DAVIS
PARTNERSHIP
ARCHITECTS

ADDENDUM NO: 03

Date Issued: December 9, 2015

**Re: Red Rocks Community College
Student Recreation Center**
Construction Documents, Dated November 9, 2015
Architect's Project No. 15803.00

EXTERIOR
ELEVATIONS

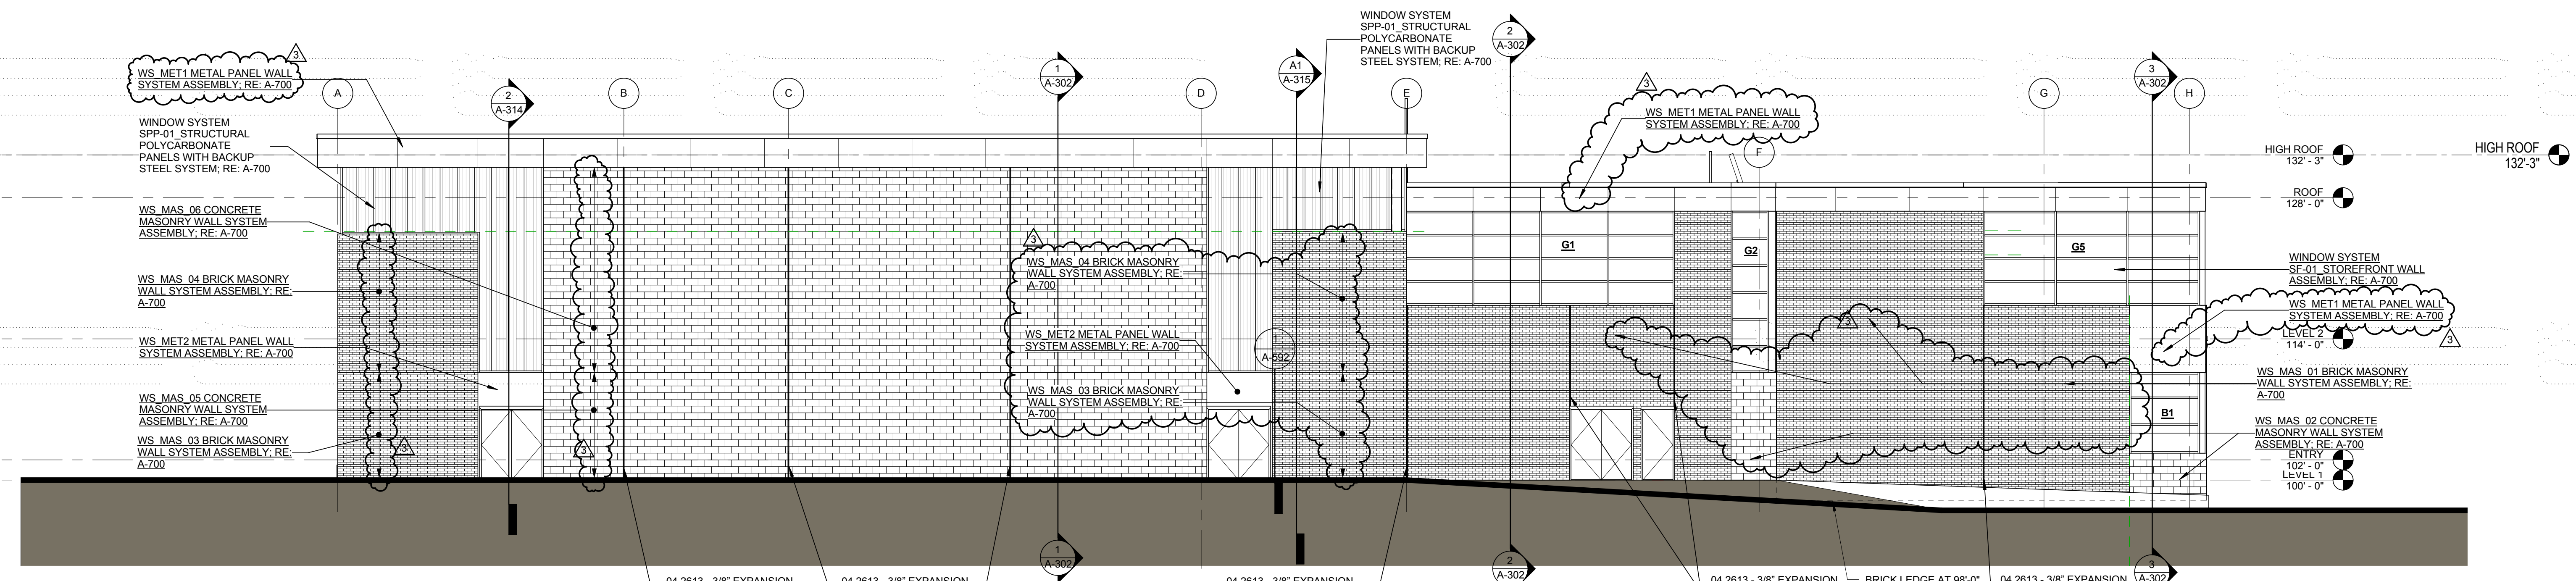
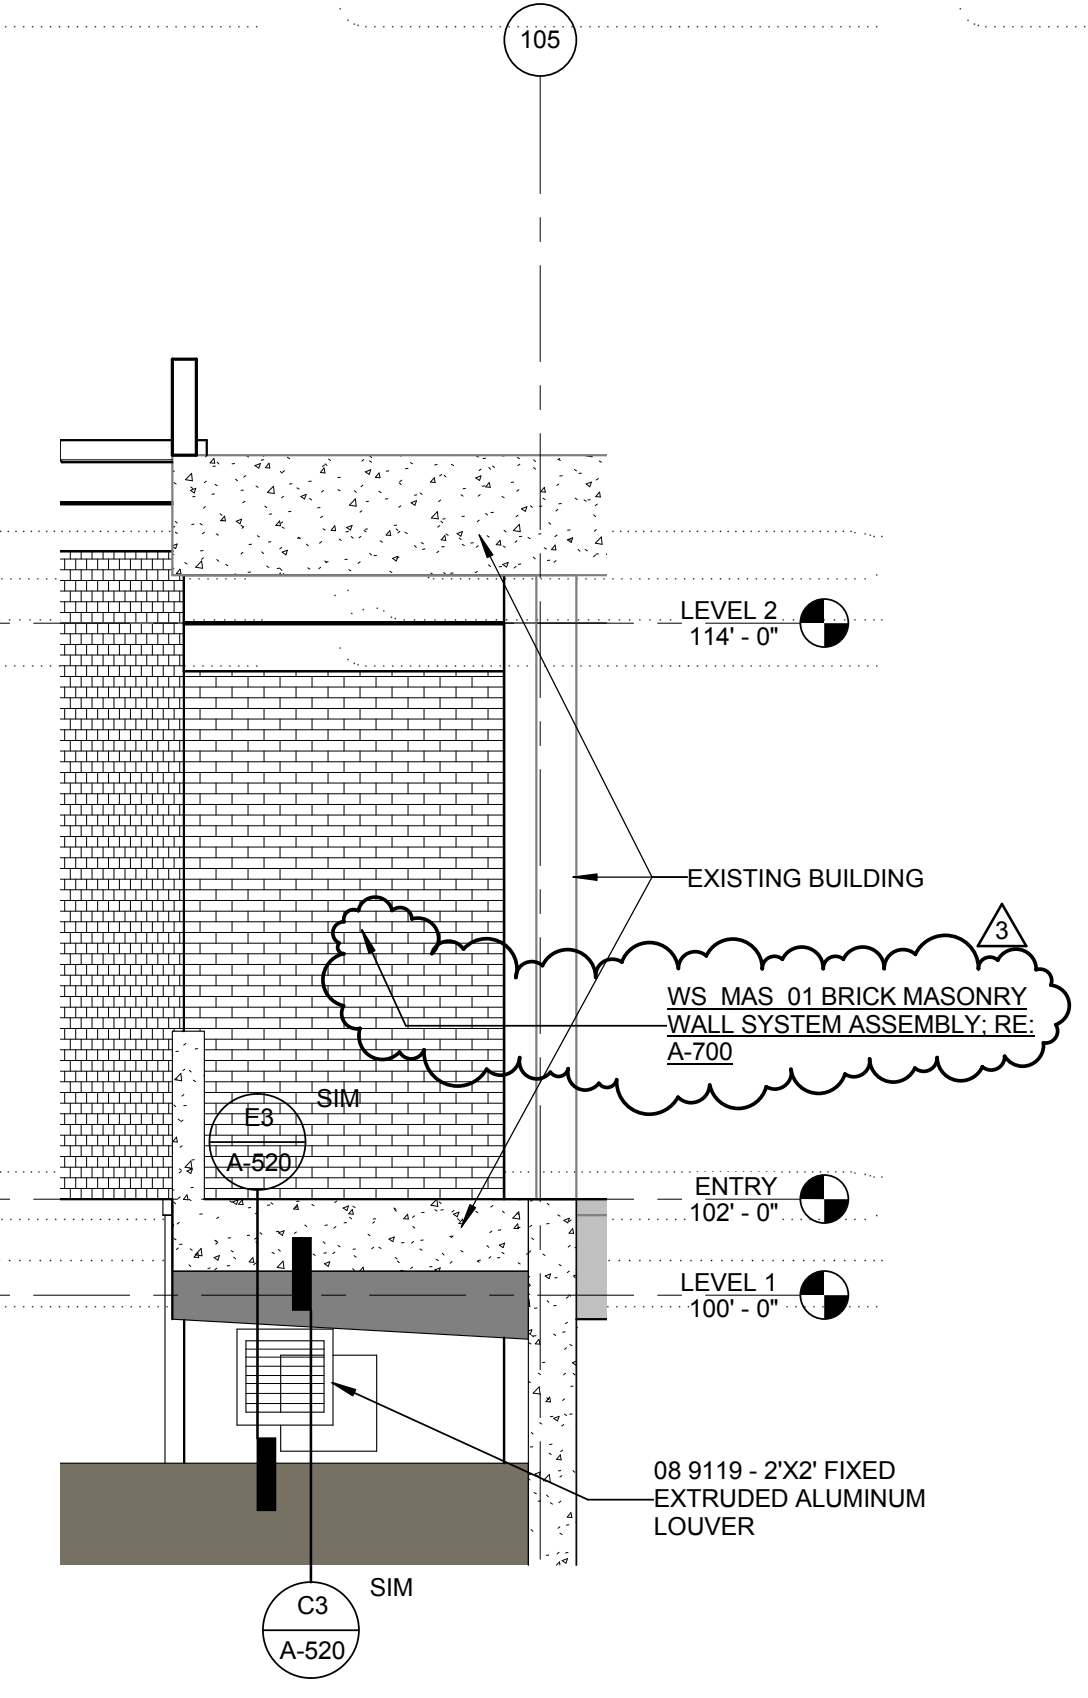
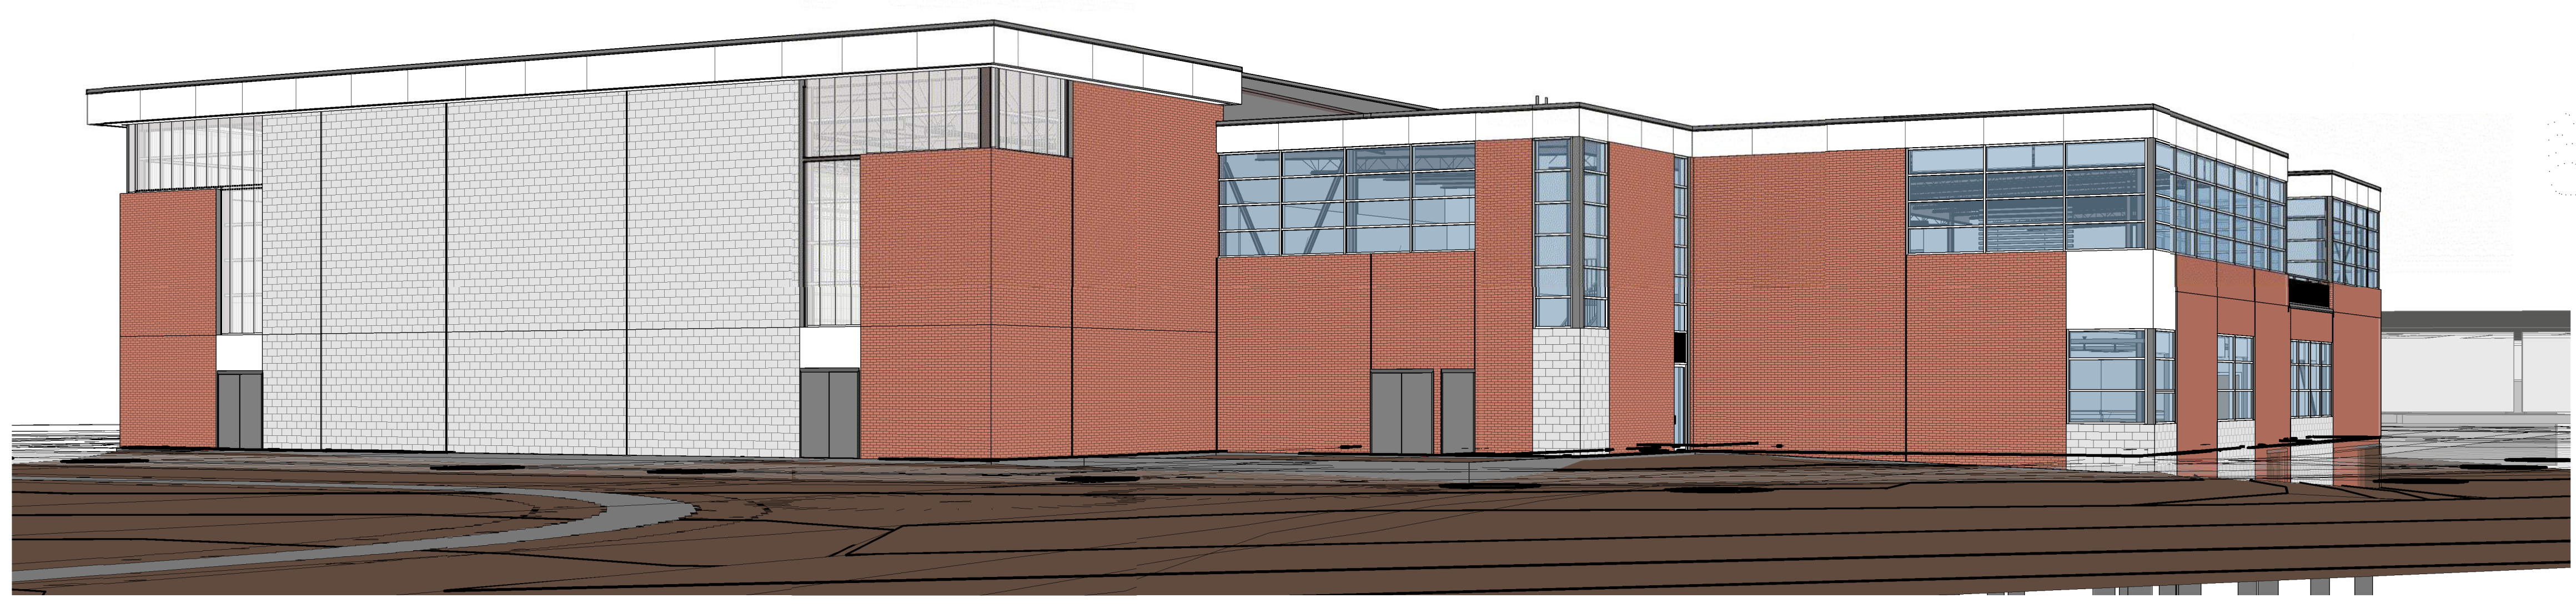
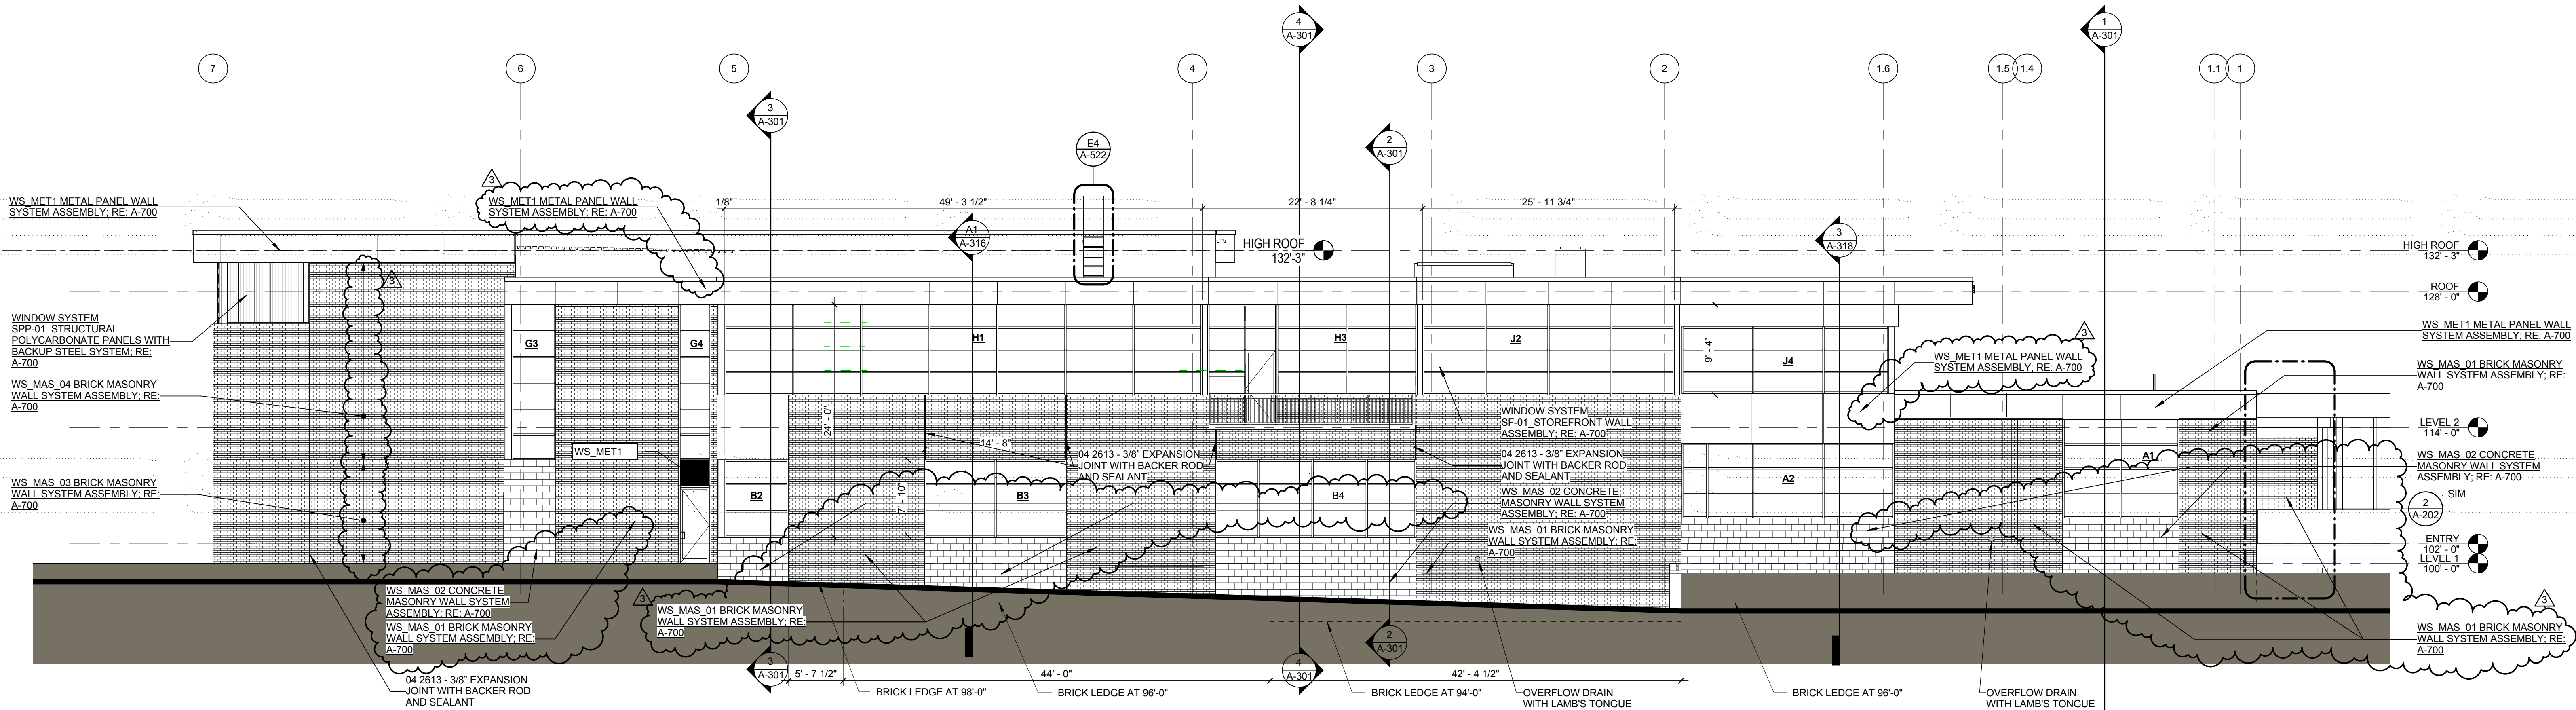
- ADD. #3-24. Sheet A-202: Detail 3: Please see the left side of the west elevation. WS_MAS_03 and WS_MAS_04 are both noted for the same wall. Please provide clarification. **RESPONSE: Please see Wall Section A3/A-313 for similar wall type. The difference in the two wall systems is the structure. There is CMU from Level 1 up to 10'-8" and Metal Stud Framing above the CMU at the Gymnasium.**

- ADD. #3-25. Sheet A-202 No clear distinction between WS_MAS_01 and the gym masonry is discernable. Please provide clarification as to where each masonry wall occurs. Some elevations are not labeled. **RESPONSE: See attached A-202 for clarifications:**

ADD. #3-50. Please provide clarification on wall type WS-MET2. Some details show the wall panels backed by masonry and other details show it backed by CMU. (For Example West Elevation between Grids 6 & 7) **RESPONSE: Please see attached sheets A-201 and A-202, elevations have been corrected.**

1. **Sheet A-201: On Detail 1 added exterior wall system callouts where elevations were missing labels.**
 2. **Sheet A-202: On Details 1, 2 & 3 added exterior wall system callouts where elevations were missing labels.**

1 ELECTRICAL ONE-LINE DIAGRAM
SCALE: NONE

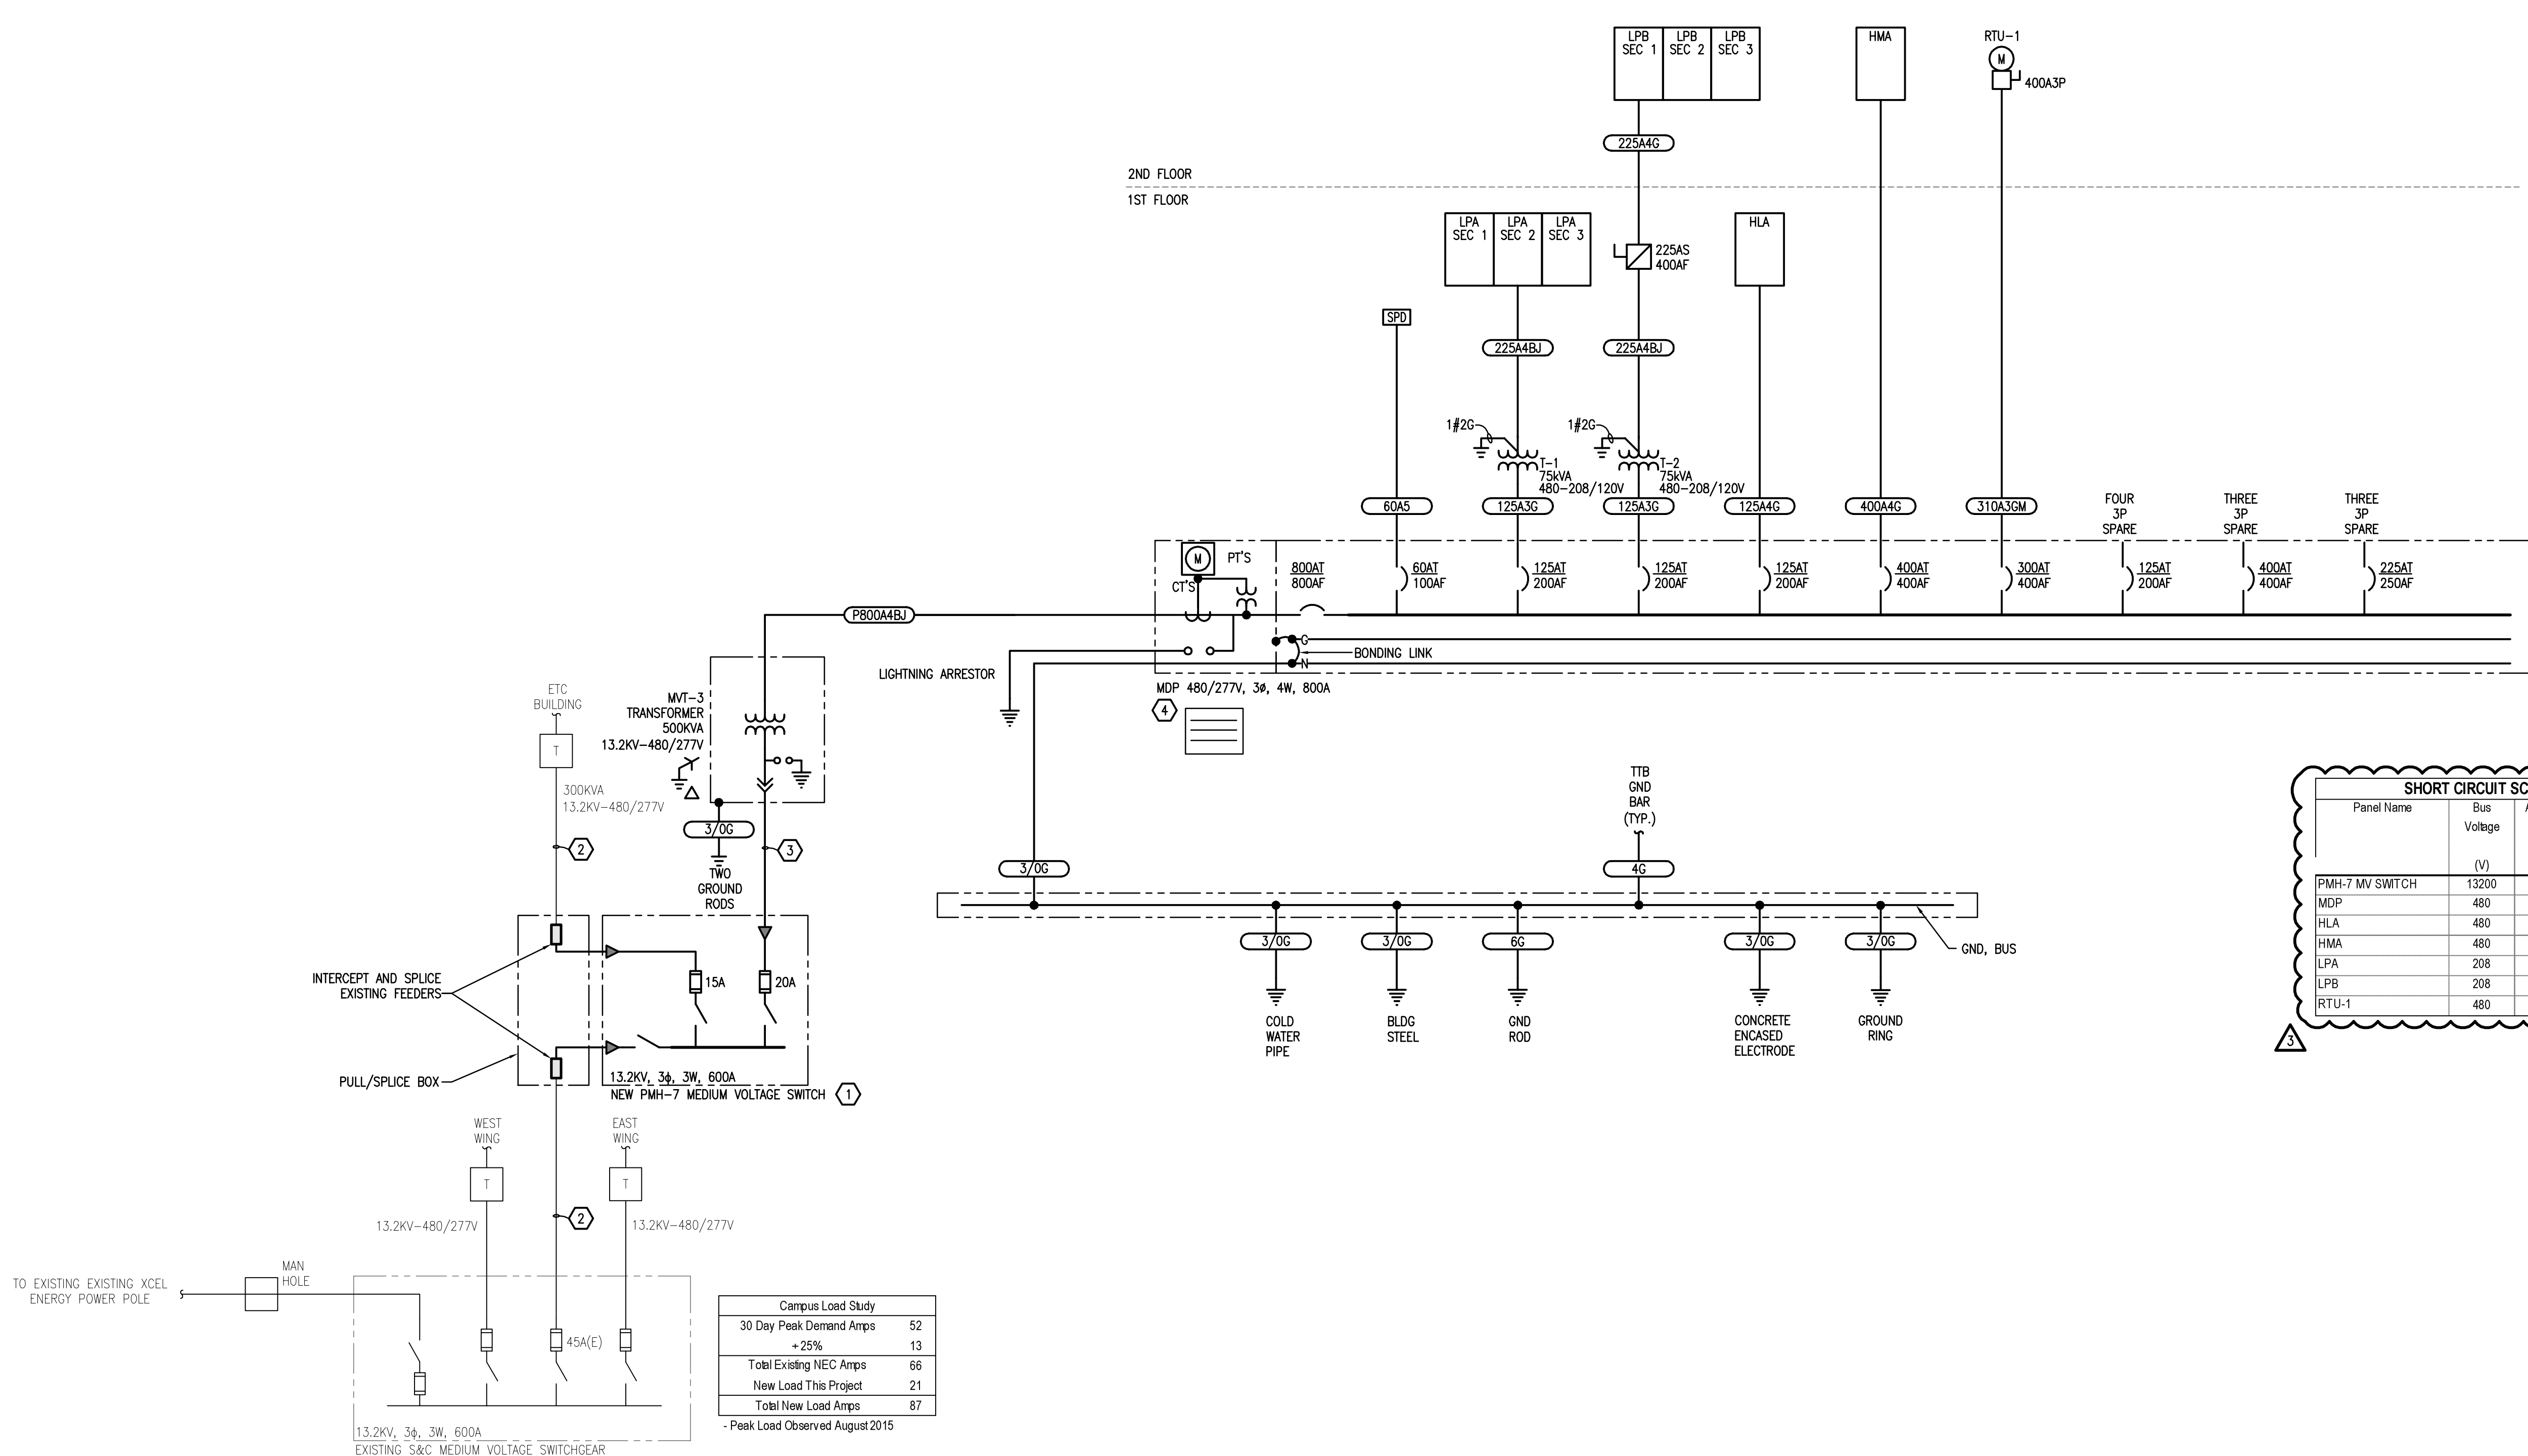
ADD. #3-80. Sheet E002 – short circuit schedule values have been updated and also include the PMH-7 medium voltage switch.
